REVISION #1 09/16/2024
REVISED SHEETS: EC1-EC3, U1-U3, U6, U7
REVISION #2 02/28/2025
REVISED SHEETS: EC1, PD4, P4, U4, S1, S2, S3, S6 - new sheet, X8, X9
REVISION #3 04/25/2025
REVISED SHEETS: PD3, P3, X5, X6
REVISION #4 04/28/2025
EVISED SHEETS: G11, G12, G14 - new sheet, PD3, P3, P4, P6, U3, U6, X4, X5

PLAN OF PROPOSED IMPROVEMENT

KNUTSON DRIVE AND GREEN AVENUE ASSESSMENT DISTRICT - 2024

CITY PROJECT NO. 13812
CONTRACT NO. 8635

13812
X-4

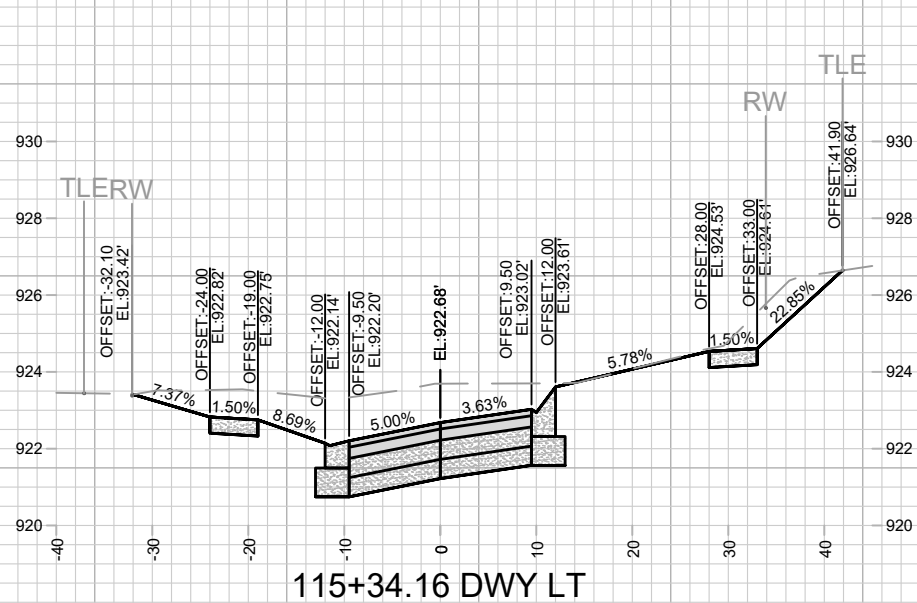
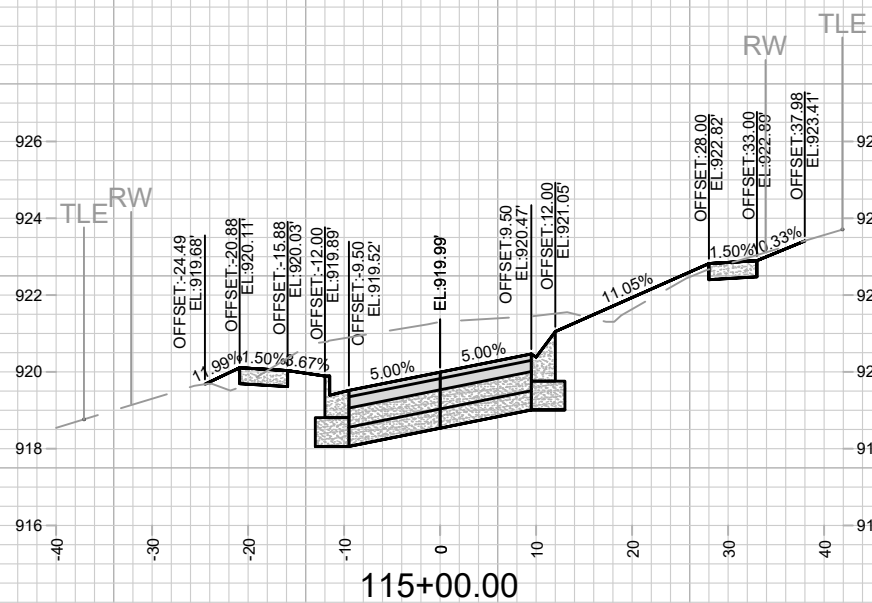
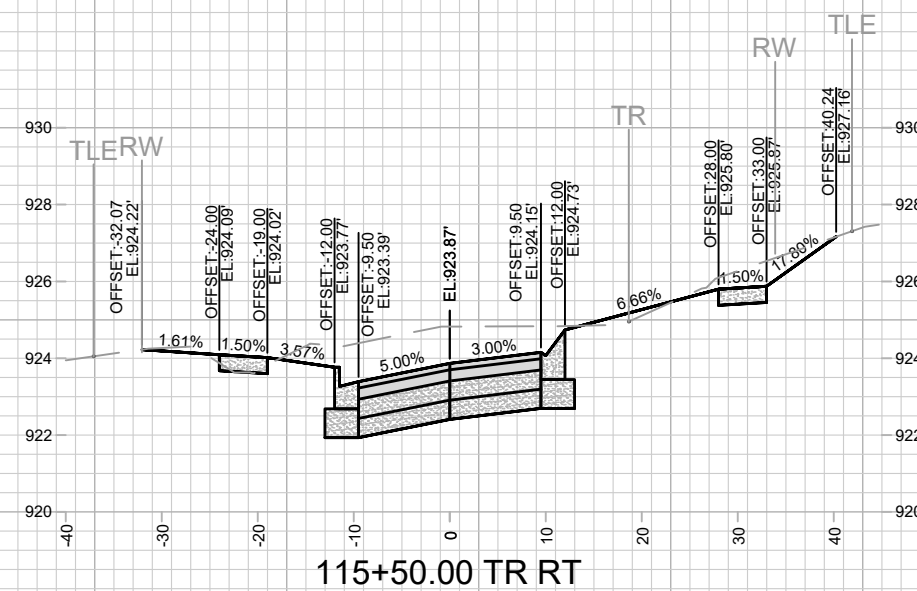
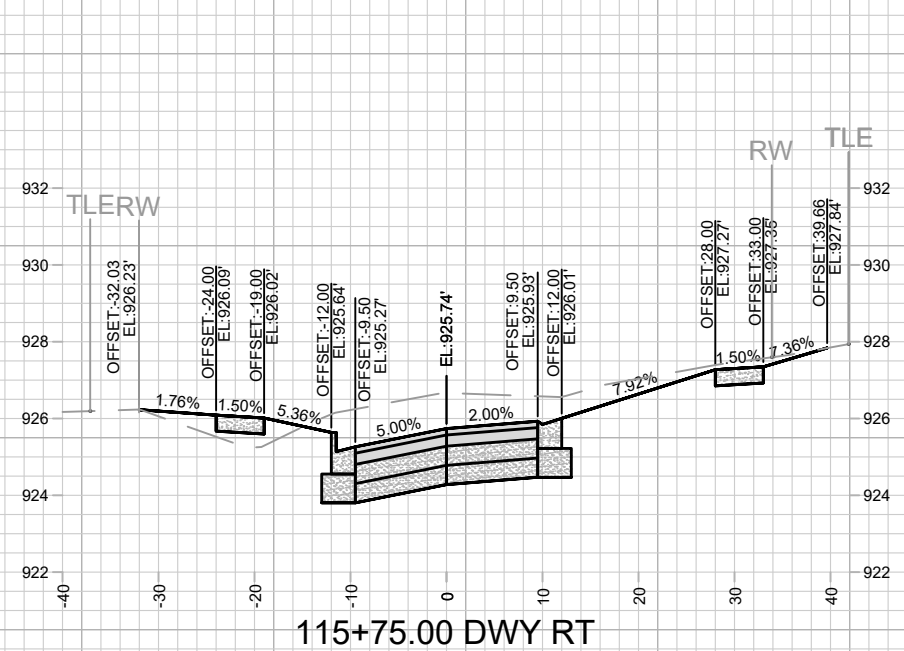
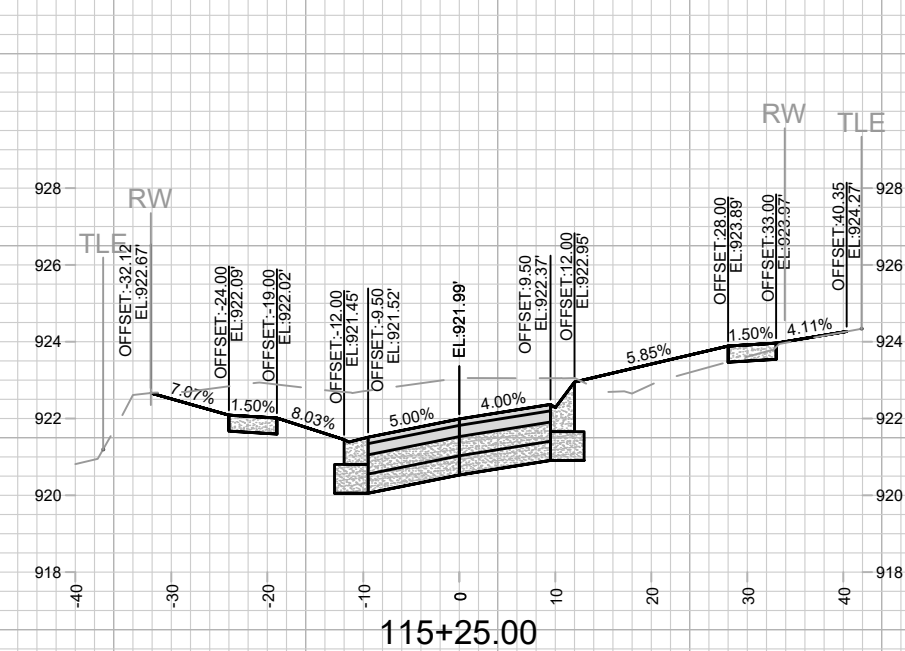
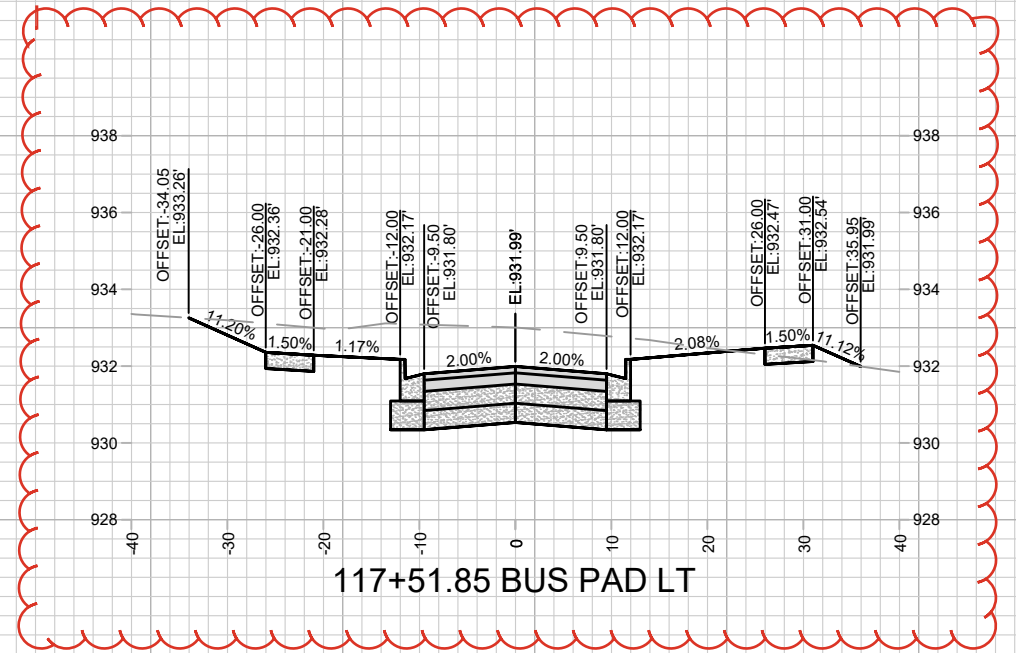
REV4	REVISE PROFILE & CROSS SLOPE	4/28/25	AJZ	DATE	BY
REV3	REVISE CROSS SLOPE	4/25/25	AJZ	DATE	BY
MARK	REVISION	13812	Scale: 1" = 20'	Designed By: AJZ	13812
MARK	REVISION	13812	Scale: 1" = 20'	Designed By: AJZ	13812

13812
X-8

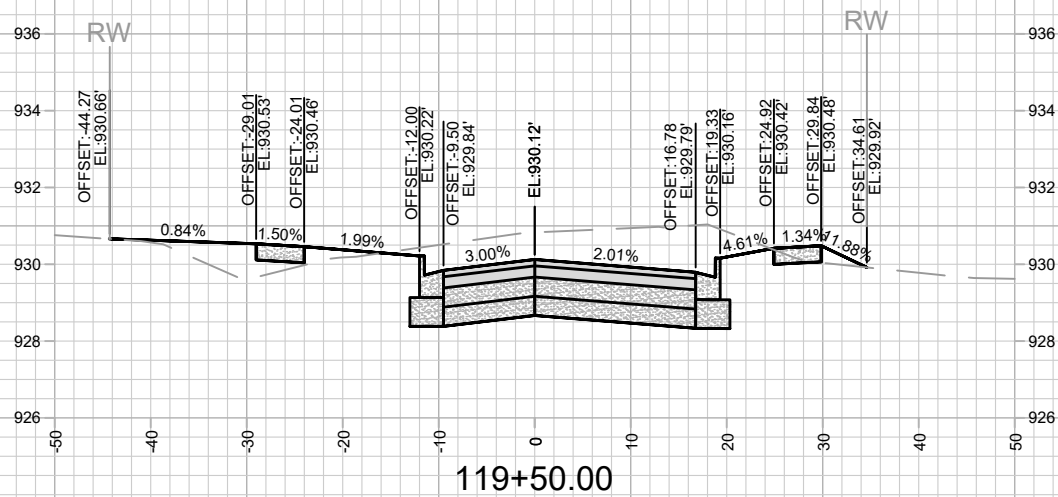
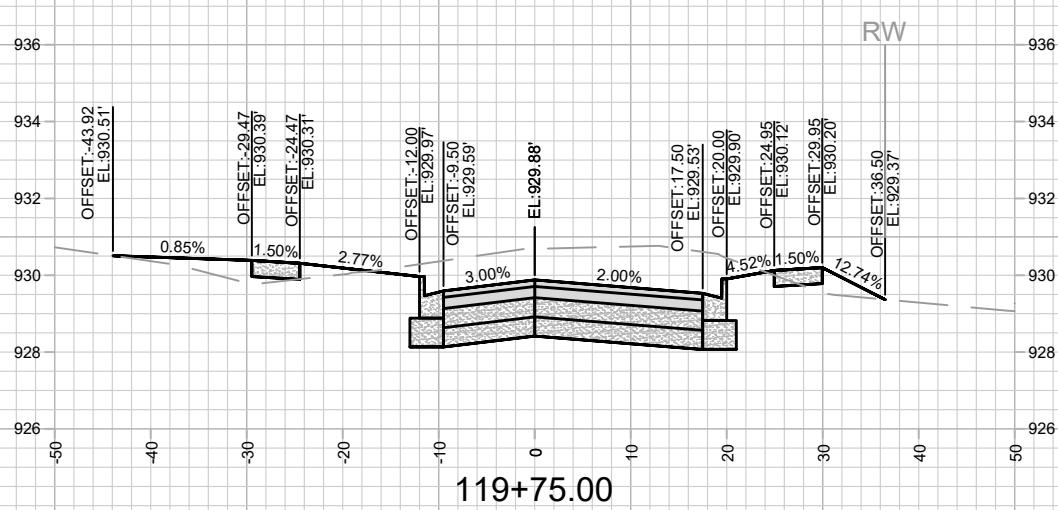
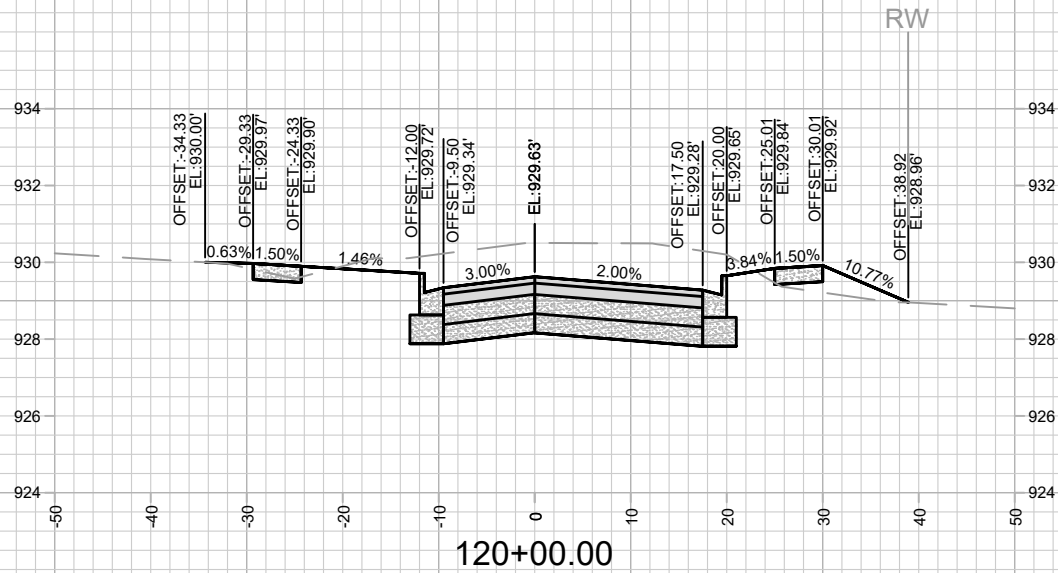
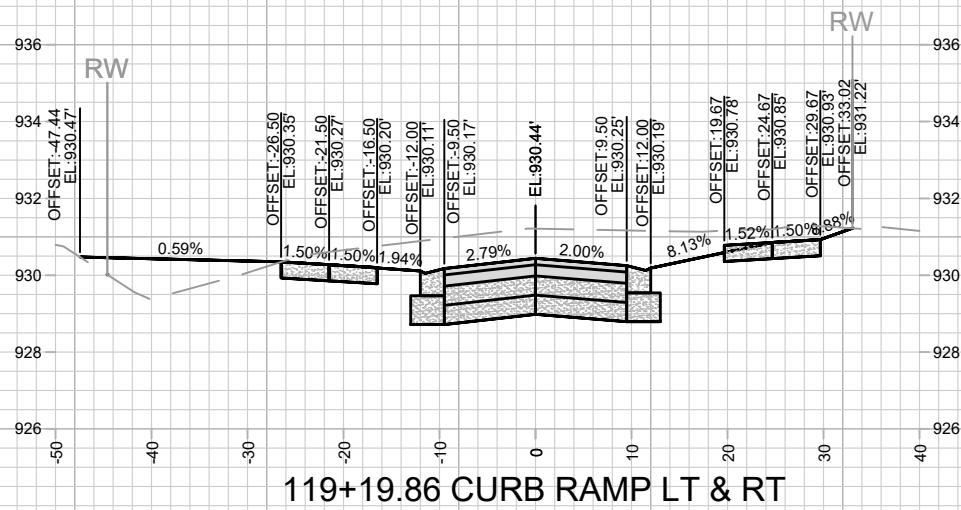
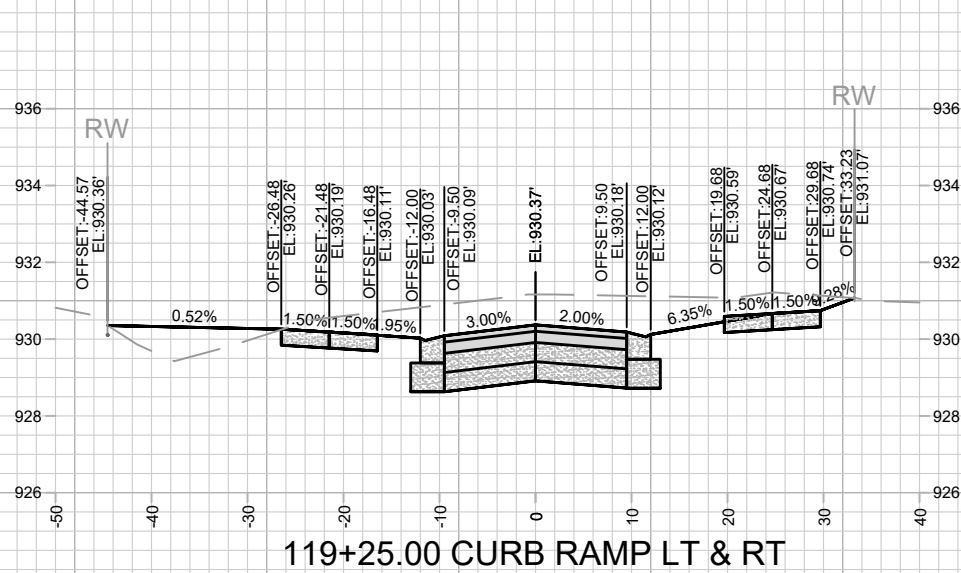
REVZ	DATE	BY
2/28/25	AJZ	BY
UPDATE PUS PADS		
MARK	REVISION	DATE
13812	12/22/2025 8:21 PM	Scale: 1" = 20'
Designed By: AJZ		X-8
